RECEIVED
AUG 24 2010
NMOC D ARTESIA**OCD-ARTESIA****SUNDRY NOTICES AND REPORTS ON WELLS****Do not use this form for proposals to drill or reenter an abandoned well. Use Form 3160-3 (APD) for such proposals.****SUBMIT IN TRIPLICATE - Other instructions on page 2**

Creek AL Federal #17

Yates Petroleum Corporation wishes to extend the captioned well's APD for one year ending 6/2/11.

PECOS DISTRICT CONDITIONS OF APPROVAL

Closed Loop Design Plan

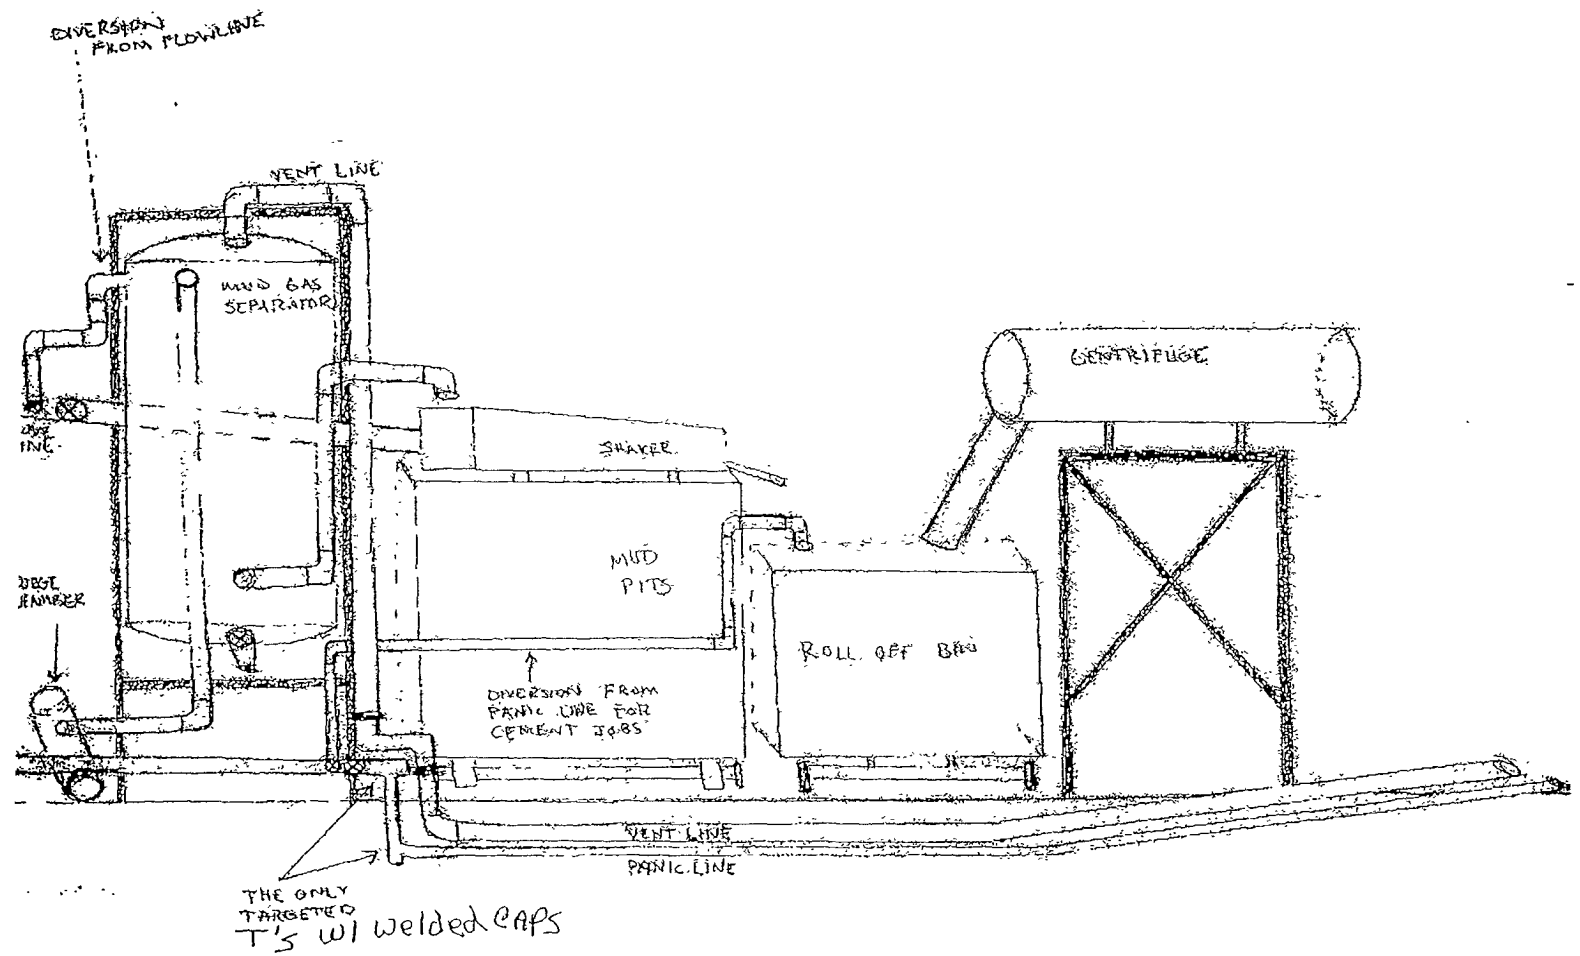
Yates Petroleum Corporation also wishes to change to a Closed Loop System.

D. CLOSED LOOP SYSTEM

Tanks are required for drilling operations: No Pits.

The operator shall properly dispose of drilling contents at an authorized disposal site.

Cross Section of a Typical Lead-off Ditch

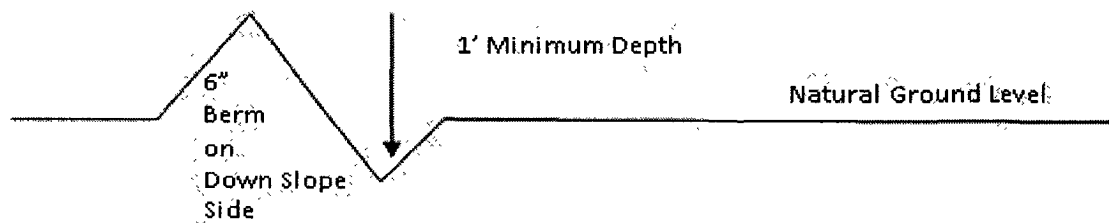
A typical lead-off ditch has a minimum depth of 1 foot below and a berm of 6 inches above natural ground level. The berm shall be on the down-slope side of the lead-off ditch.

All lead-off ditches shall be graded to drain water with a 1 percent minimum to 3 percent maximum ditch slope. The spacing interval are variable for lead-off ditches and shall be determined according to the formula for spacing intervals of lead-off ditches, but may be amended depending upon existing soil types and centerline road slope (in %);

Figure 1 – Cross Sections and Plans For Typical Road Sections

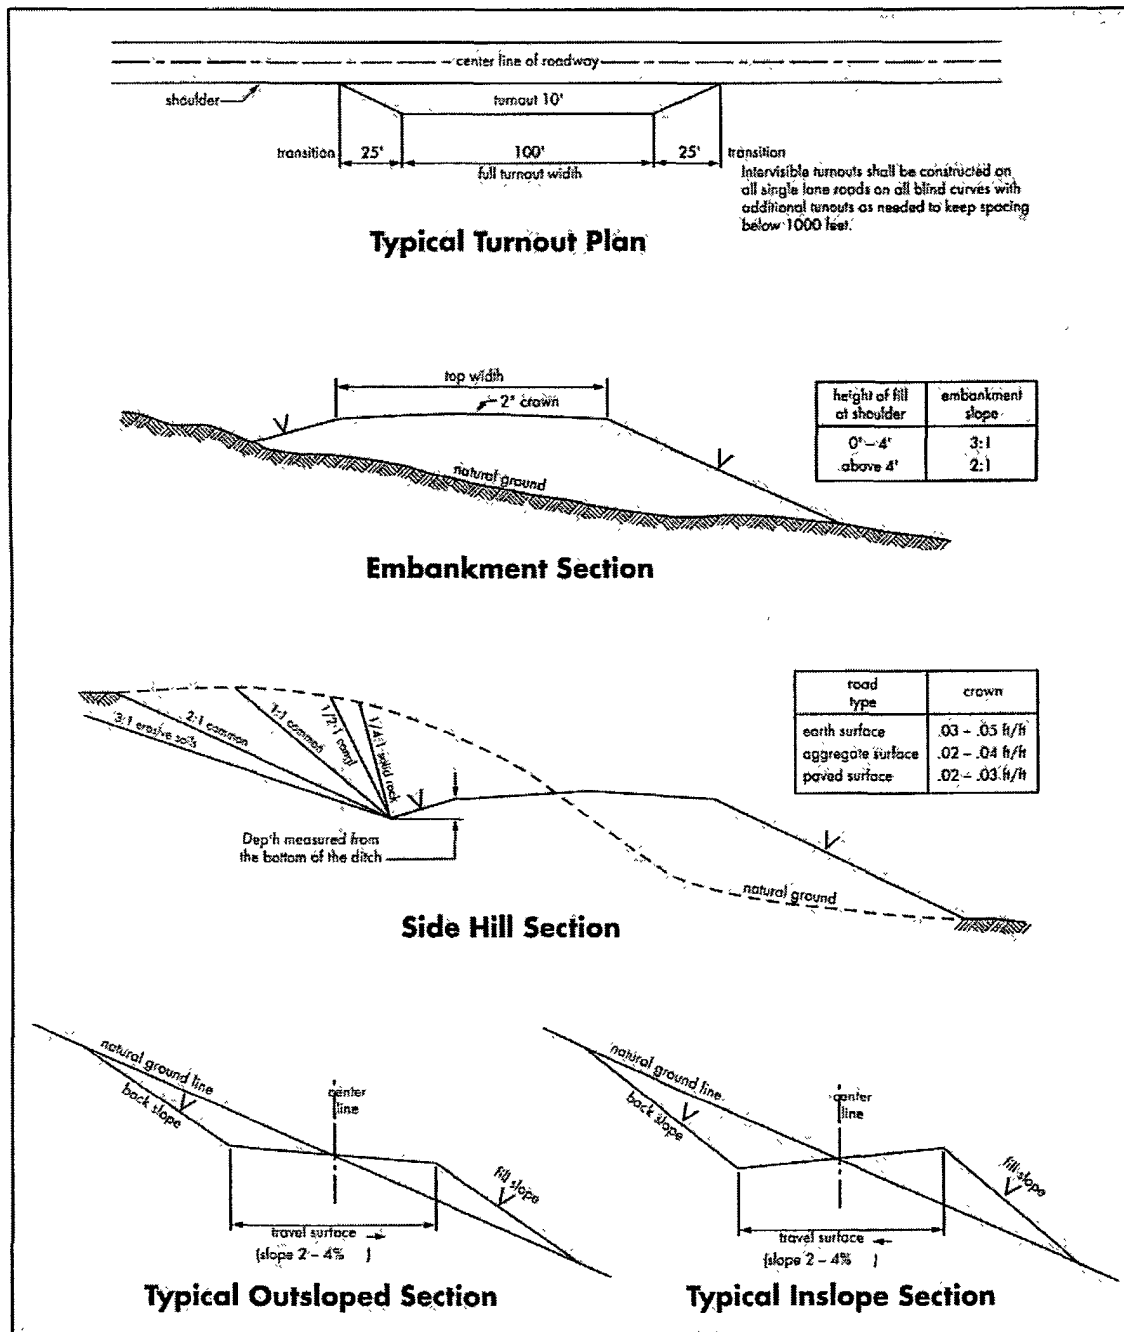
Crowning shall be done on the access road driving surface. The road crown shall have a grade of approximately 2% (i.e., a 1" crown on a 14' wide road). The road shall conform to Figure 1; cross section and plans for typical road construction.
